WSDOT Scour – Q&A

Questions are organized by each component of total scour, scour countermeasures, streambed construction and SMS/Hydraulic Toolbox

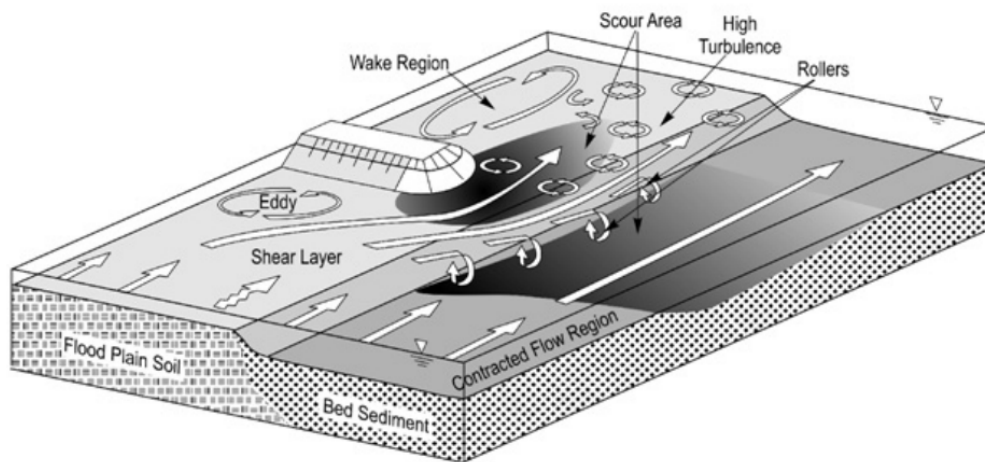
2. What is the difference between NCHRP equation (Abutment scour in Hydraulic toolbox) and contraction scour? In what occasion will we want to use contraction scour equation?

The NCHRP local abutment scour equations and the contraction scour equations need to be evaluated separately. It is true that per the NCHRP method, abutment scour is related to general contraction scour, but both situations need to be evaluated by delivery teams for each individual crossing and flow rate. There is a simplifying assumption in the NCHRP abutment live-bed scour equation for the exponent. It should result in small differences in live-bed contraction scour. Contraction scour may be needed when you are out of the crossing or have no abutment scour within the crossing. Please see footnotes in the table in the current template. Below is a good example of a table with appropriate footnotes.

Calculated scour for SR XX XXX Creek		
	Scour design flood	Scour check flood
Long-term degradation (ft) ¹	X.X	X.X
Contraction scour (ft)	X.X	X.X
Local scour (ft)	X.X	X.X
Total depth of scour (ft) ^{2, 3}	X.X	X.X

¹Reflects the largest end of the range of long-term degradation estimated to be present in the worst-case scour scenario; long-term degradation should be refined in the FHD phase.

²Contraction scour is not included because the local scour method outlined in NCHRP 24-20 includes contraction scour in its estimate, so the two are not additive.

³Total depths of scour are assumed to be relative to and extending below the thalweg elevation.

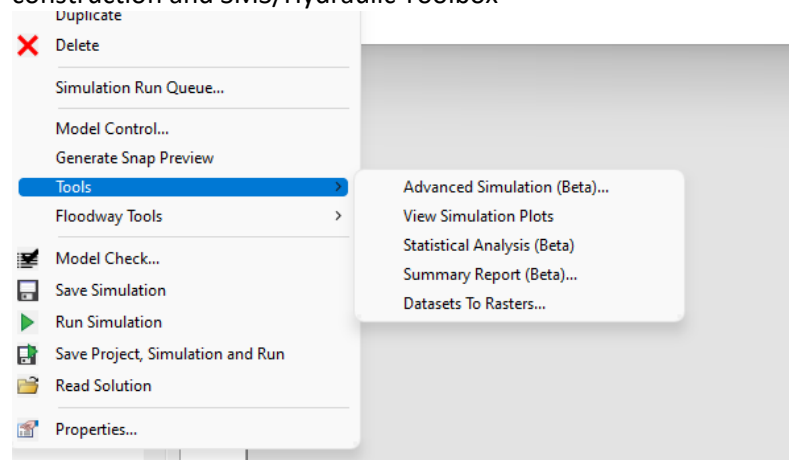
- 1. It sounded like [we] should draw the abutment arc at the toe of the main channel and have the bank lines at the top of the main channel instead of MHO. This is a little different from my design assumption. I thought the main concern of the scour analysis is for the structure. We are planning to calculate scour caused by habitat features in the crossing, but we've acknowledged there will be localized scour around the features and they are part of the design.**

SMS abutment arcs are currently intended to be drawn at the abutment or abutment toe. SMS only uses the intersection of the abutment arc with the contracted section arc to (1) read a y_o value (i.e., flow depth at abutment toe prior to scour) and (2) to plot the local scour hole in the plot feature of Hydraulic Toolbox, which feature we are not using. When drawing abutment arcs in areas of low flow depth (or zero depth), teams need to pay attention to the y_{max} value and reference it to the thalweg elevation for Section 7 reporting...to aid in this, teams should also get in the habit of manually entering in the flow depth at the thalweg for y_o in Hydraulic Toolbox, which will assure that the scour depth and elevation are correctly referenced to the thalweg.

Bank arcs, on the other hand, need to be carefully drawn through a variety of items, including an assessment of where live-bed sediment transport occurs (e.g., using the CVI coverage in SMS), the topobathymetry of the “main channel” (top of bank to top of bank, or toe to toe), field information, and vegetation.
